**STATE OF TENNESSEE  
DEPARTMENT OF TRANSPORTATION  
DESIGN DIVISION**

**INSTRUCTIONAL BULLETIN NO. 13-08**

**Regarding New and Revised Standard Drawings**

**Effective for the July 12<sup>th</sup> letting (May 1<sup>st</sup> turn-in),** the following Standard Drawings are new or revised and Section V of the Design Guidelines is revised for this update.

STATE OF TENNESSEE  
DEPARTMENT OF TRANSPORTATION  
**SIDE DRAIN CONCRETE ENDWALL WITH STEEL PIPE GRATE**  
FOR 15" THRU 48" PIPES - 6:1 SLOPE

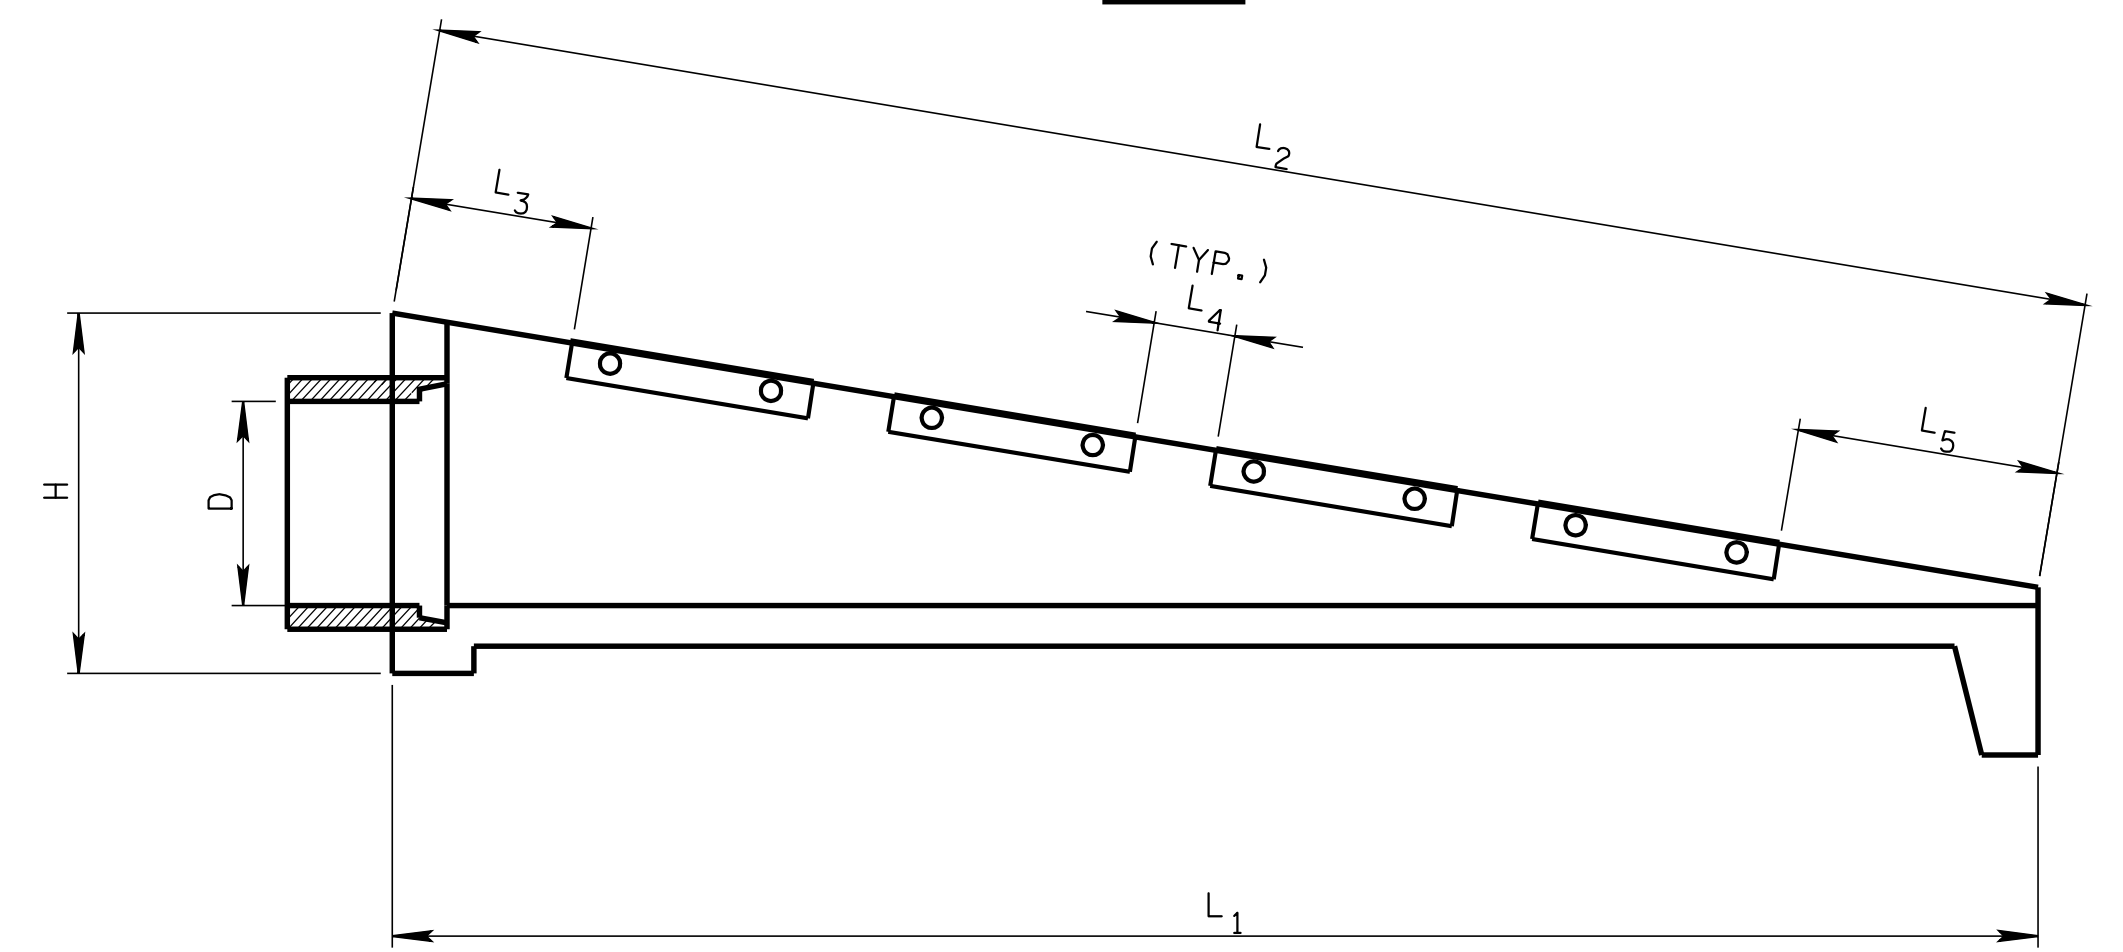
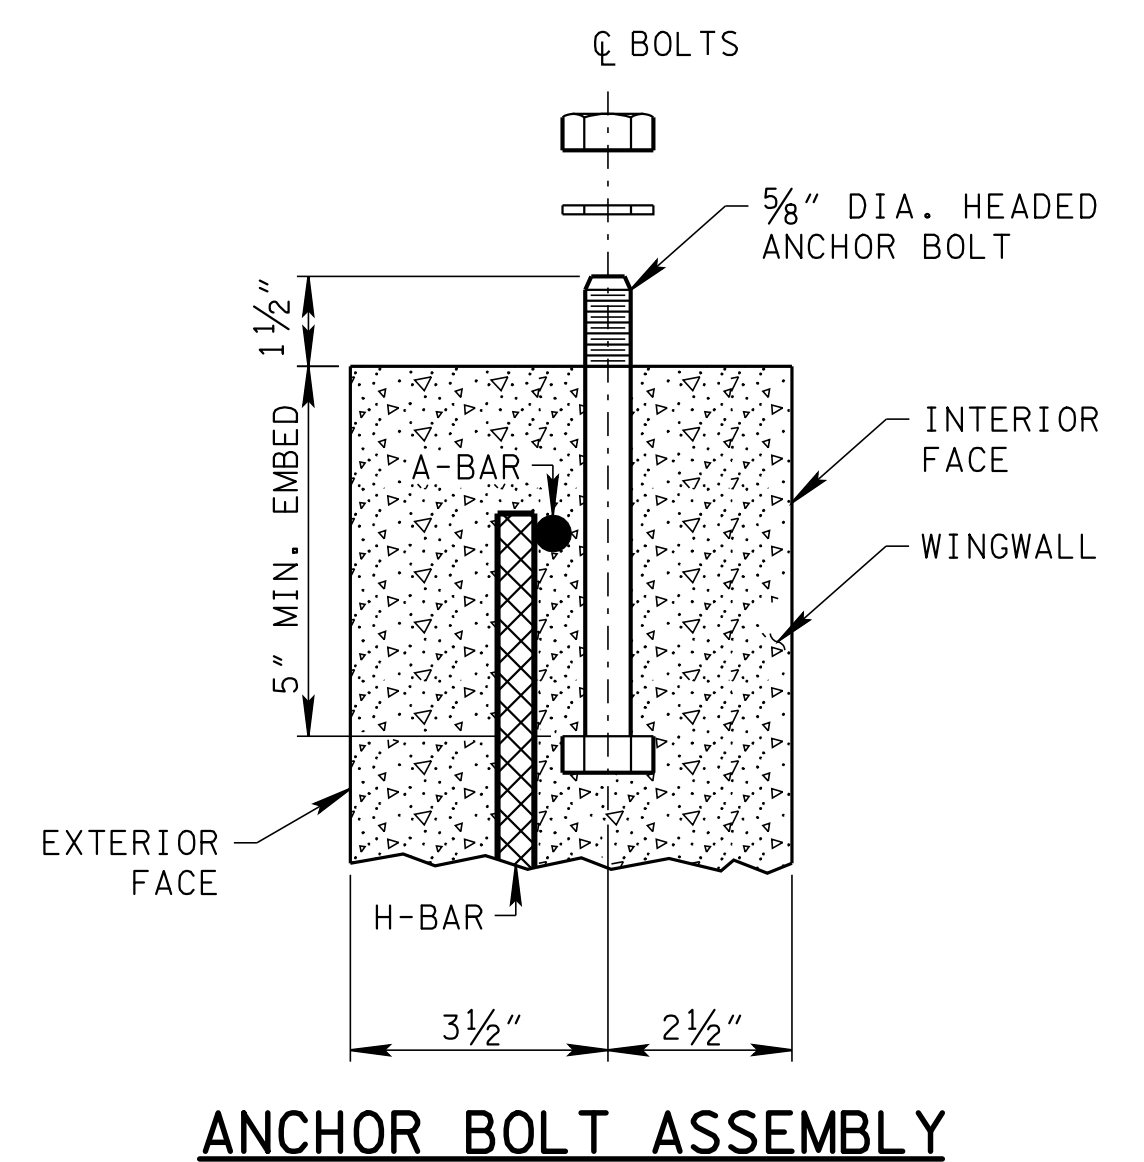
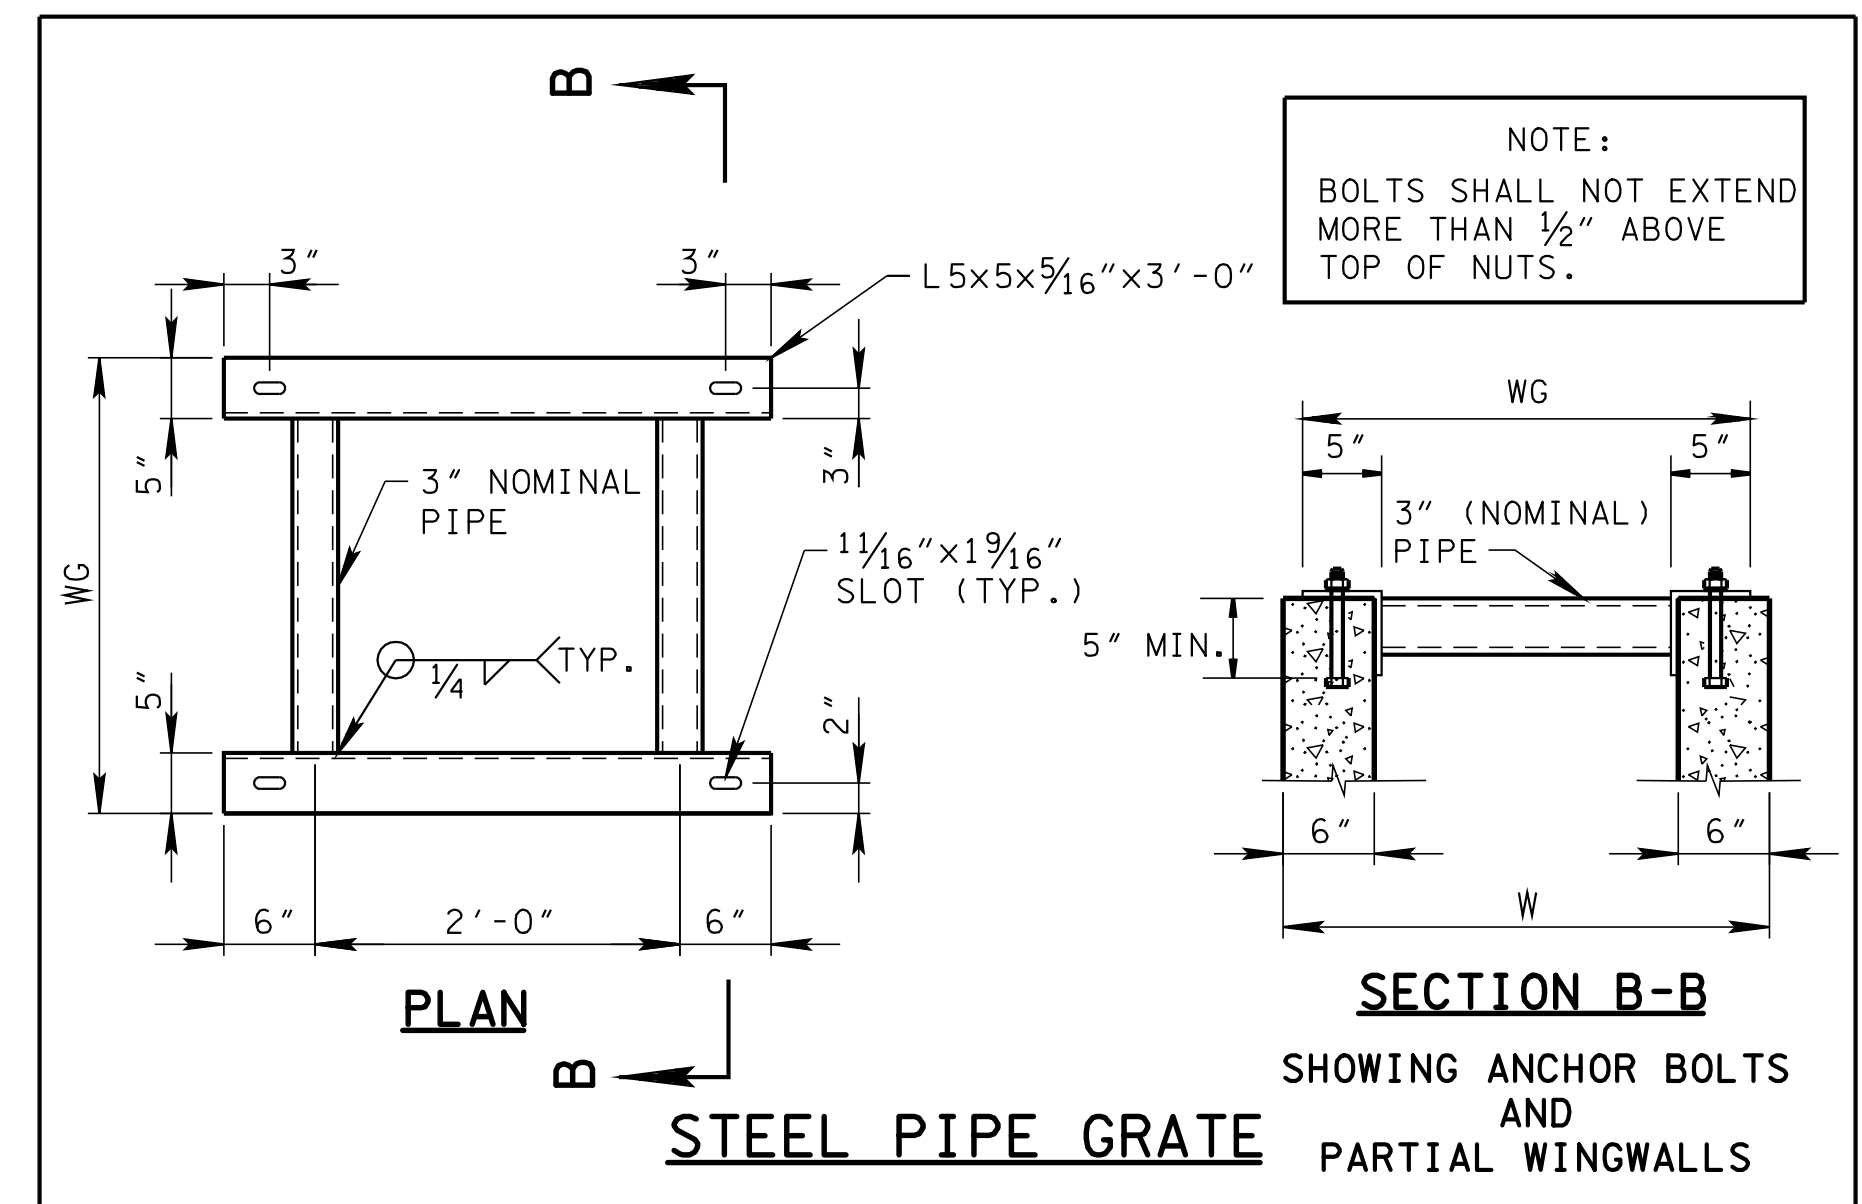
- REV. 7-10-12: REVISED ALTERNATE ANCHORS FOR STRUCTURAL STEEL GRATES NOTE.
- REV1-10-13: CHANGED REQUIREMENT FOR GRATE ON ALL ENDWALLS.

- 48" ENDWALL - SEE D-PE-48A & D-PE-48B WITH 6:1 WINGWALL SLOPE
- NOTE: ALL SIDE DRAIN CONCRETE ENDWALLS REQUIRES STEEL PIPE GRATES SHOWN ON THIS DRAWING. FOR 30" THRU 48" THE CONTRACTOR SHALL OMIT THE CONCRETE BLOCKOUTS AS SHOWN ON THE ABOVE DRAWINGS, FOLLOWING REINFORCING BAR SUBSTITUTIONS ARE REQUIRED:
